OCSS Review

- This report was produced as a collaboration between Ardleigh Parish Council and the Essex, Suffolk, Norfolk, Pylons campaign group to discuss the termination of the Offshore Coordination Support Scheme (OCSS), as announced by the Department for Energy Security and Net Zero (DESNZ) on 3 September 2024.

These comments are in response to submission: "EN010115-000598-DESNEZ Letter to Essex County Council.pdf" from Mark Woodger – Principal Planner National Strategic Infrastructure Projects at Essex County Council.

NGET Norwich to Tilbury Proposed Infrastructure

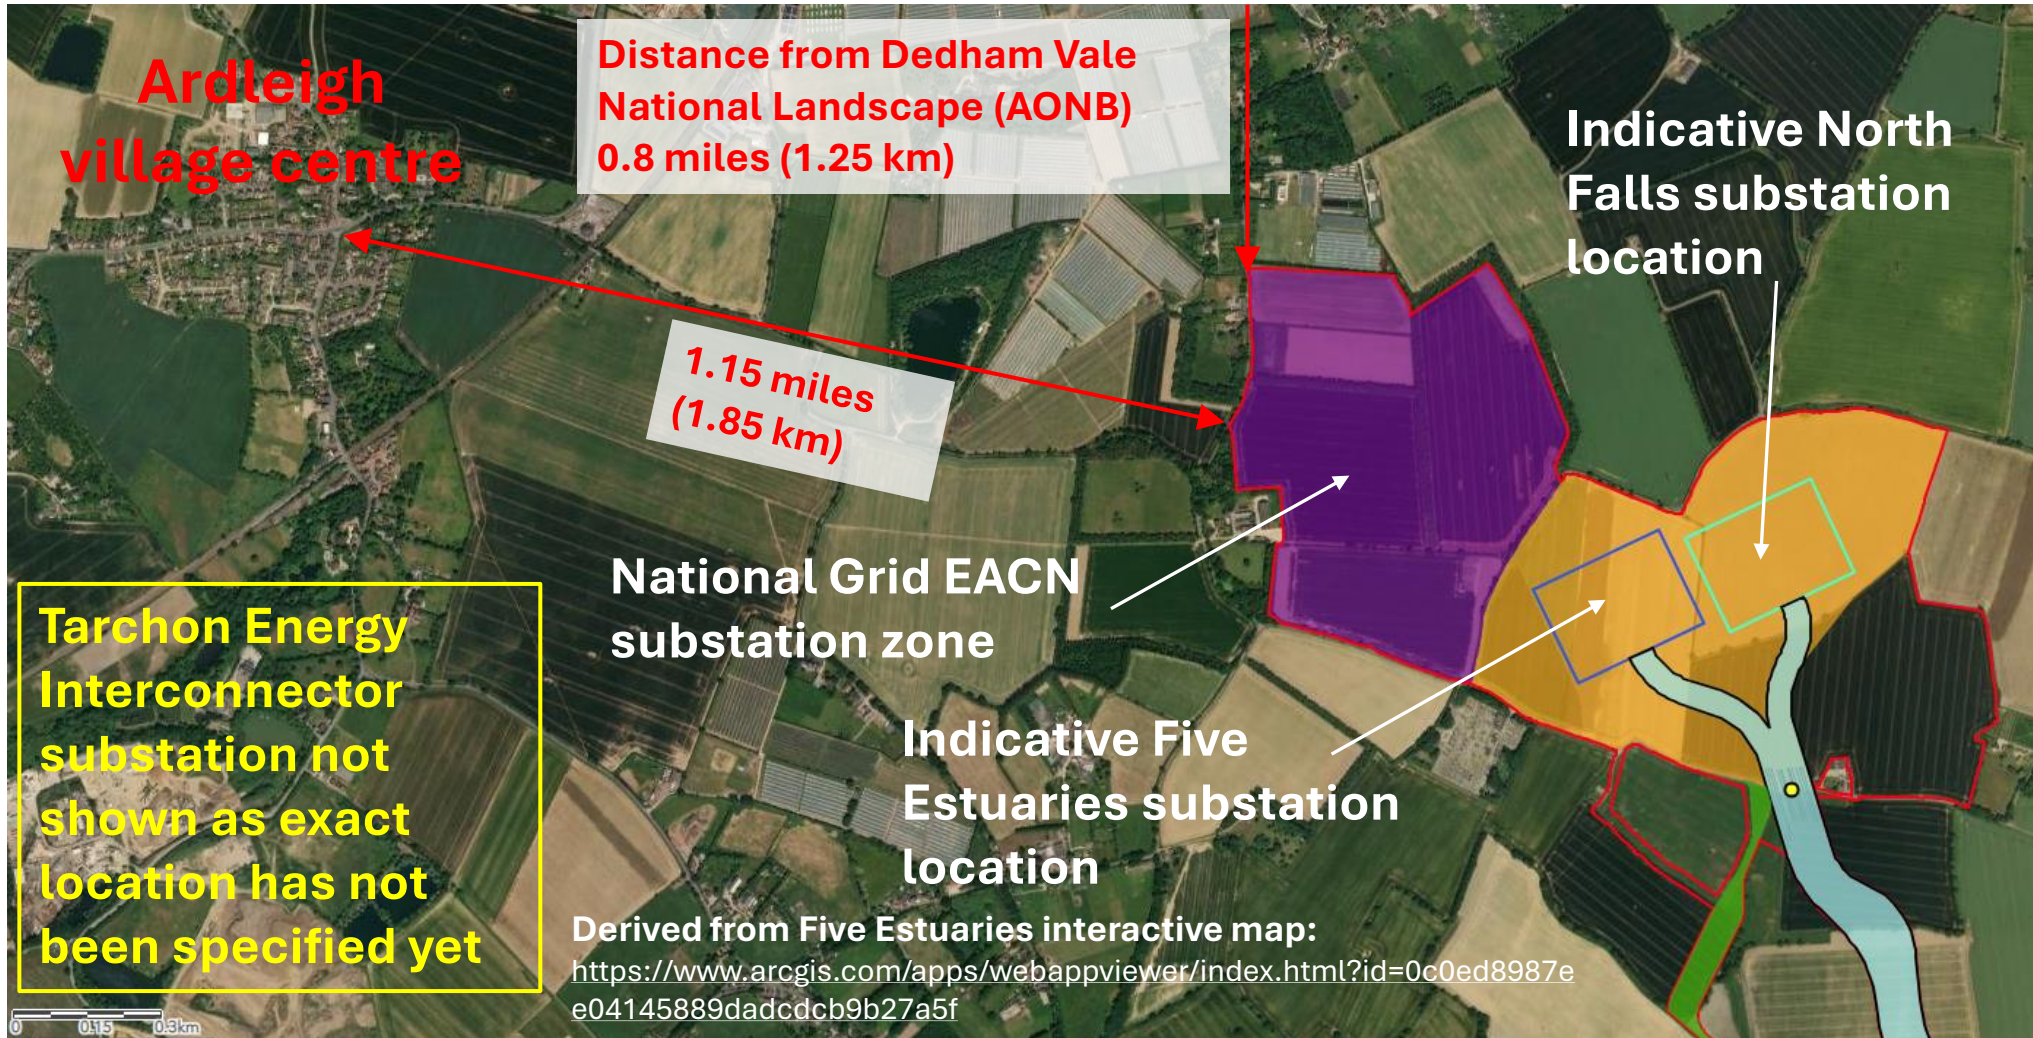
NGET proposal for new overhead lines to wrap around the village of Ardleigh: *View to the South East*

In this section it is also proposed by NGET that 18 underground HVAC cables closely follow the proposed OHL route shown to the proposed EACN Substation

NGET proposal for new overhead lines to wrap around the village of Ardleigh: *View to the West*

Proposed Substation Sites

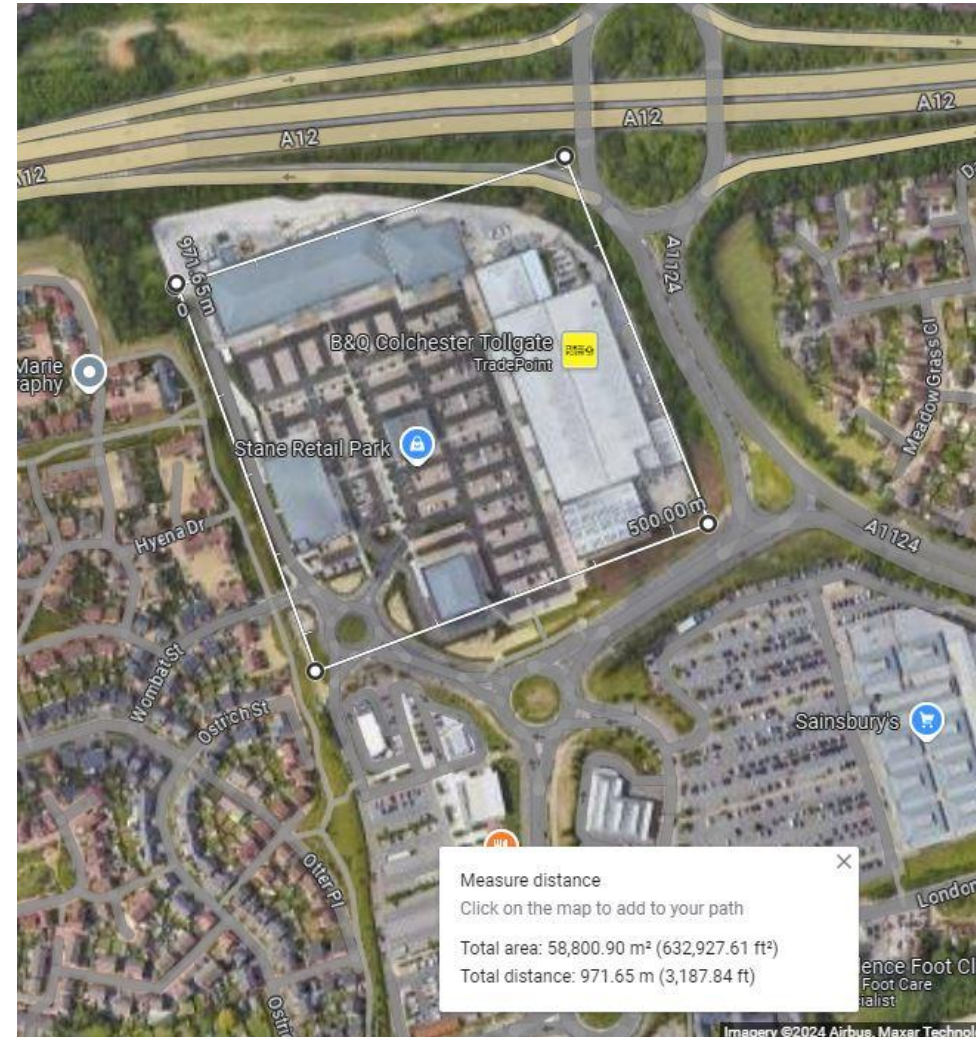
- Each of the onshore windfarm substations has a total land requirement to the perimeter fence of 58,800 square metres (5.9Ha or 14.5Acres), as well as “*additional land required for the TCC, roads, drainage and cut/fill*”. <https://infrastructure.planninginspectorate.gov.uk/wp-content/uploads/projects/EN010115/EN010115-000470-6.1.1%20Onshore%20Project%20Description%20Revision%20B.pdf>

- The white square overlaid in the image to the right illustrates how 58,800 square metres compares with the Stane Retail Park site in Colchester.
- As can be seen, the land area of **each** of the substations is roughly equivalent to that of the whole of the retail park site (which includes a B&Q warehouse, a M&S superstore and other stores plus a carpark etc.).

- The current proposal is that two windfarm substations of this size are built on BMV farmland in unspoilt countryside.
- No details are available yet, but a third substation for the Tarchon interconnector is also proposed to be built adjacent to these. This will require a large AC/DC converter.

Heritage Assets at Risk Due to Proposed Substations

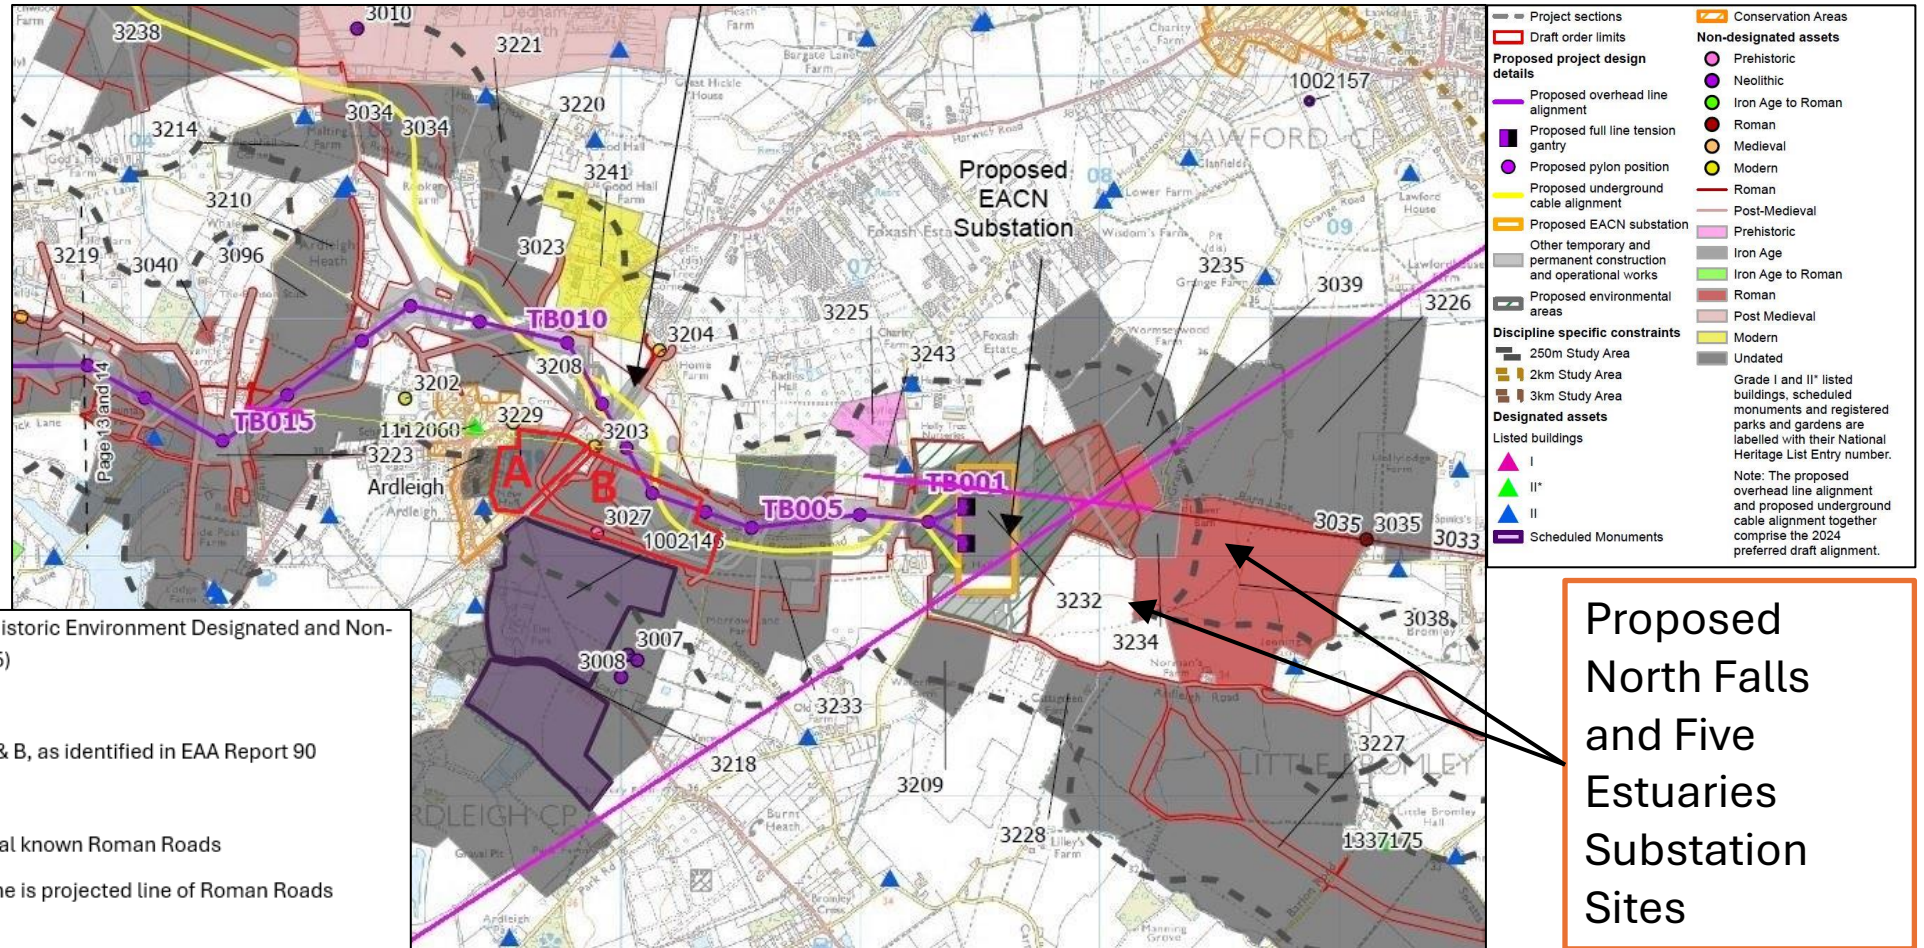
- Within the parish there are 71 listed buildings (69 Grade II and 2 Grade II*) and many other heritage assets. 47 of the listed buildings are located within 1km (0.6 miles) of the proposed Norwich to Tilbury infrastructure. Many of these are a risk of harm, along with many other heritage assets including a Scheduled Monument.

- The current proposals would also cause direct and irreversible harm to non-designated heritage assets of archaeological interest that are of equivalent significance to the adjacent to the Scheduled Monument. In accordance with Overarching National Policy Statement for energy (EN-1) these are afforded the same protection as a Scheduled Monument. These are referenced as “Areas A & B” in this document.

- The following slide provides an illustration of how extensively heritage assets are at risk. The map was produced by NGET, but further details have been added. It can be seen that the routes of two Roman Roads intersect the proposed EACN substation site. Please note that a very limited number of the listed buildings are shown, as the majority had not been included in the NGET study. These and other heritage assets that are not included in the NGET consultation documents are detailed in the Norwich to Tilbury Historic Environment submission produced by Ardleigh Parish Council, along with detailed information on the harm that would result.

“Stylised representation of the Baseline – Sea Link, North Falls and Five Estuaries” from “Independent Review of OCSS Qualifying Coordinated Project”.

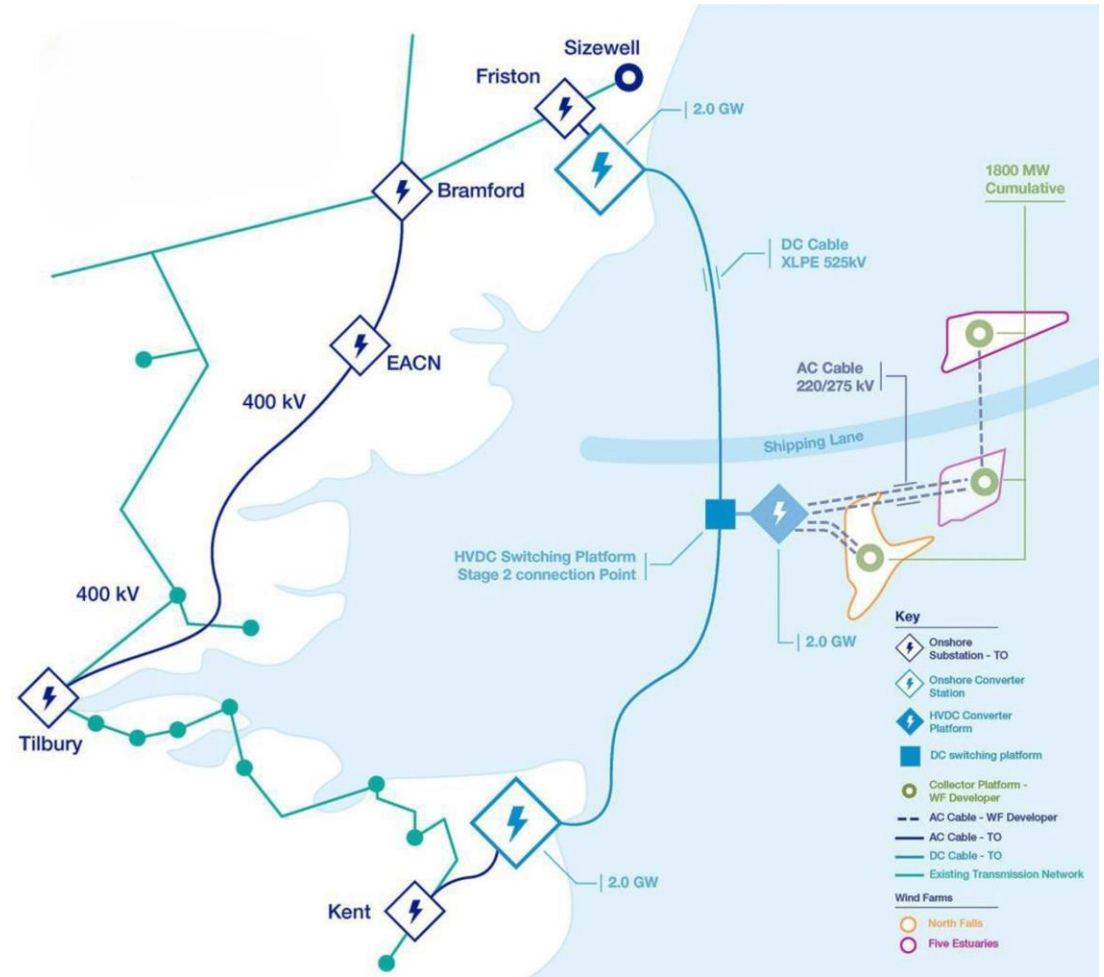
- In the current HVAC based proposal, a total of 4 export cable circuits are required for North Falls and Five Estuaries.
- As the 3 phases of the AC circuits each require a separate power cable, a total of 12 power cables are needed with the current proposal.
- This results in 12 separate onshore export power cables (and 12 separate cable ducts) as denoted by the additional annotations in the figure on the right, and 4 x 3 core offshore export cables*.

OCSS Alternative Solution

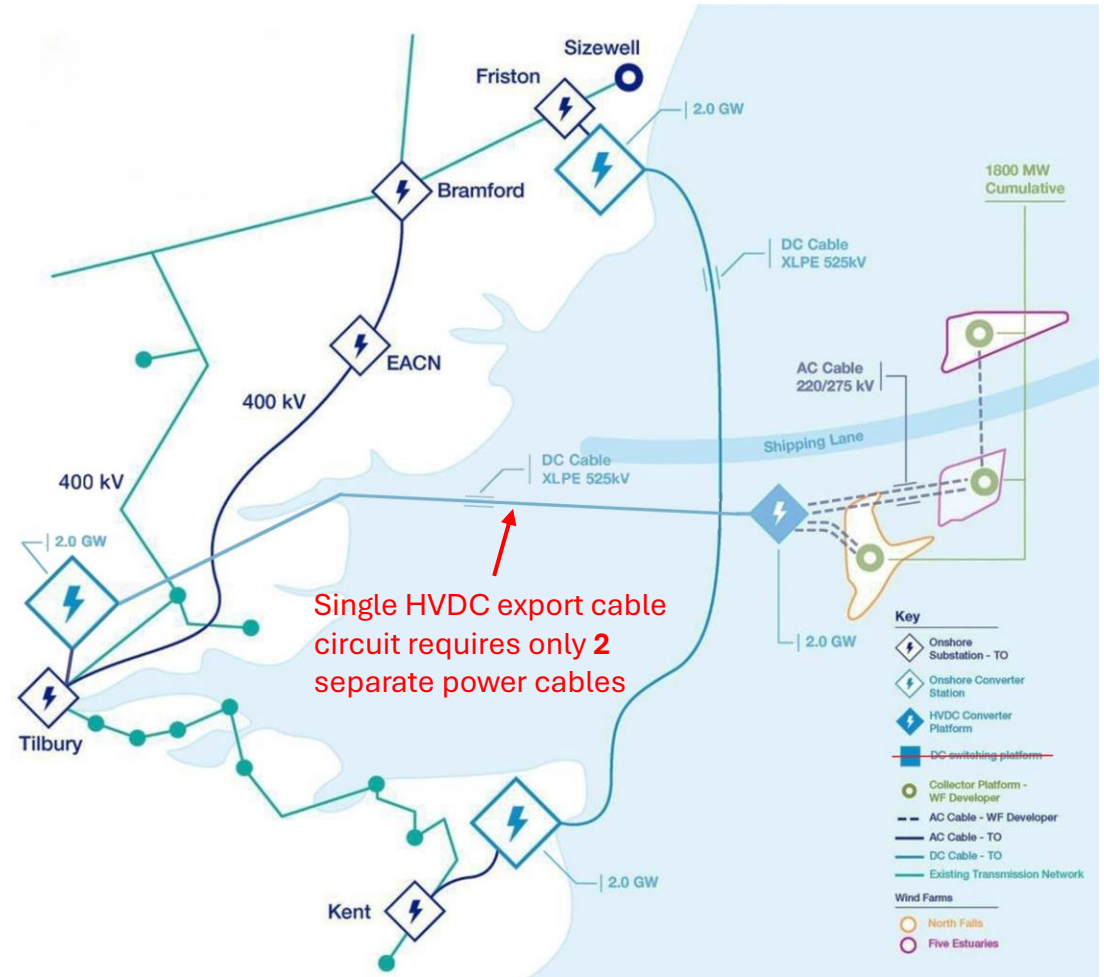
- This proposal would involve a 2GW offshore HVDC converter station located within the NF array area, as per the two options explored as part of the OCSS. However, instead of connecting to SL, a dedicated 2GW HVDC cable system would be used to deliver the combined power from VE and NF to the grid using brownfield sites where possible.

- The suggestion here is that the cable makes landfall at Bradwell-on-Sea but then continues underground to Tilbury as HVDC, where conversion to HVAC takes place at a brownfield site. This would provide a connection to the grid at the destination of the NGET Norwich to Tilbury project so that the power is delivered to where it is needed. It therefore avoids the need for a converter station on a greenfield site or on a protected coastline.

- Only one HVDC cable pair would be required to deliver the export power specified for the OCSS scheme, due to the significant capacity advantages over HVAC. This would result in a dramatic reduction in the number of windfarm export cables required and therefore a corresponding reduction in the harm caused both onshore and offshore.

- As per the OCSS it removes the need for VE and NF to each have a separate substation. The HVDC solution suggested here would instead involve just one converter station serving both windfarms and this would be located on a brownfield site at Tilbury.

- Huge reduction in the number of onshore & offshore export cables, substantially reducing harm.
- 2 x single core HVDC cables (onshore & offshore) instead of 4 x 3 core offshore export cables & 12 x single core onshore export cables in the current HVAC Baseline proposal.
- Utilises the 2GW Offshore Converter Platform proposed as part of the OCSS.
- 1 x onshore substation instead of 2 (one for VE and one for NF) in the current HVAC baseline proposal. Substation will though need to be a HVDC converter.
- Uses brownfield site for substation instead of greenfield.
- Connects to the grid at Tilbury where the power is needed.
